Amendment, Permit # B23003991

I am requesting to amend **Permit #** B23003991 **at** _____ **to**
The pavilion was moved approximately 5' closer to septic reserve per approval from Health
Department

**PLOT PLAN
WILLOW POND**
PLAT NO. 20374
TAX MAP 34 GRID 17 PARCEL 444
6505 HEATHER GLEN WAY
ELECTION DISTRICT NO. 5
HOWARD COUNTY, MARYLAND
SCALE: AS SHOWN MARCH 2024 1 OF 7

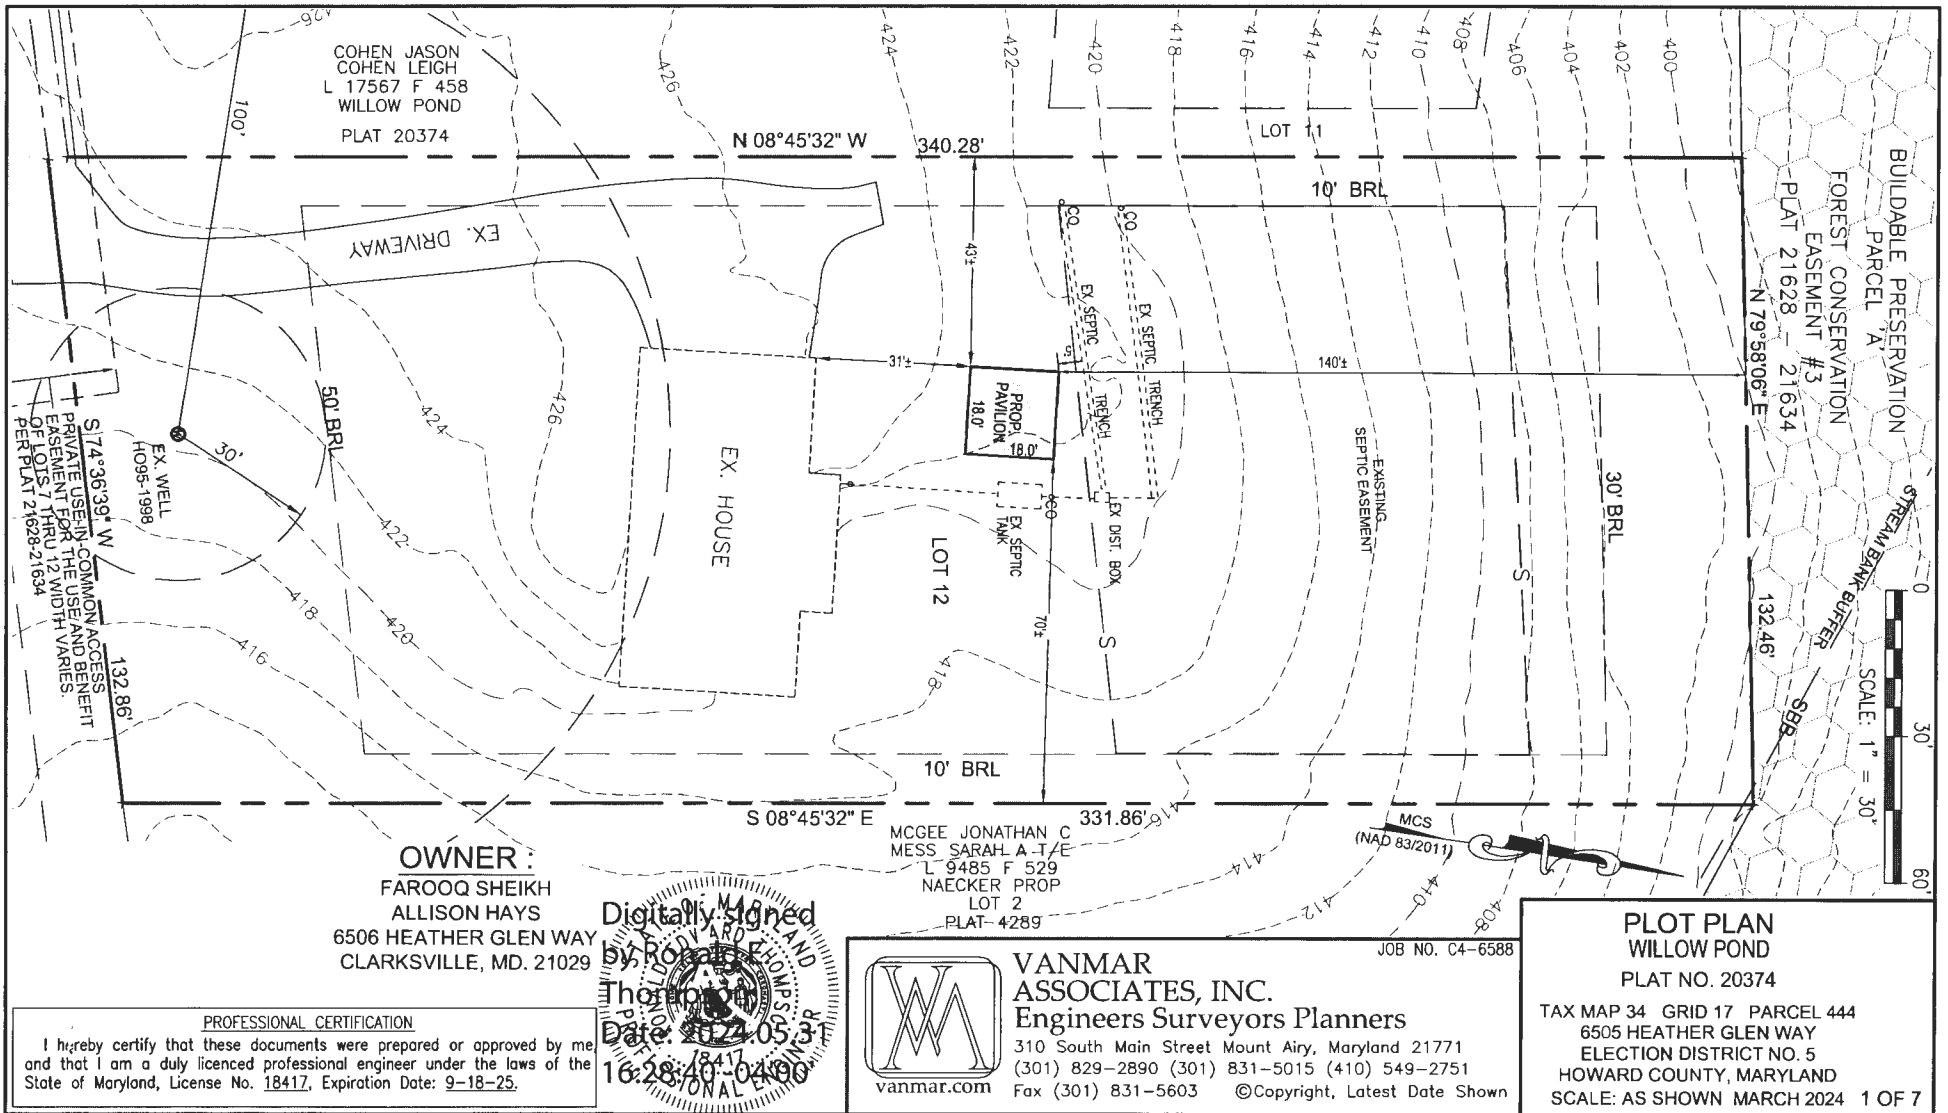
Attached is the revised layout with the 5' dimension from the edge of the upper trench. We were originally told verbally we could possibly get to the 3' dimension. The pavilion has been staked in the correct 5' dimension from edge. Oak Hill Construction did the marking and they dug the upper trench up and found the edges.

Hello. The next step will be to clearly stake out the proposed pavilion location and the locations of the upper disposal area boundary line, the full length of the upper trench, and the septic tank (unless there are already cleanouts showing its location). We will need to perform a site visit to review before waiver consideration. The plan shows a 3' label, but it is unclear what they are measuring. Please note that the pavilion must be at least 5' from the edge of the upper trench for waiver consideration.

Hello. I cannot approve a waiver to allow the pavilion to be located within the sewage disposal area. I am open to a pavilion location up to 5' from the existing trenches. The pavilion cannot get closer than 5' to the tank or trenches. If you wish to locate the pavilion less than 5' from the sewage disposal area, but not encroach into it and stay 5' from the trenches, I can consider that waiver. First you will need a septic contractor to field locate the upper trench and mark it out in the yard (its full length). Then, you could mark out the disposal area and the pavilion for our field review and waiver approval.

Hello. I reviewed the waiver request to move the proposed pavilion at 6505 Heather Glen Way inside the 5' setback to the sewage disposal area. I have a few questions related to this waiver request:

- The waiver request mentions that the owners would ideally like the pavilion in the spot where the playground was located. I want to clarify what location is being requested and what might be approved with a waiver. Are they asking for the pavilion to be in the location of the playground with this request? Looking at the aerial photos and the septic install as-built drawing, the playground appears to be well inside the sewage disposal area and over the current trench locations. I want to make sure they understand that location is not possible with a waiver and that is not what they are asking for now.

Thanks. Yes, this is a new location based on their field location of the trenches per my requirement.
Thanks

Yes, we do understand the playground area extends well into the sewage disposal area. After discussion with the homeowners, they would like to ask consideration to extend within the area closer to the first trench line.
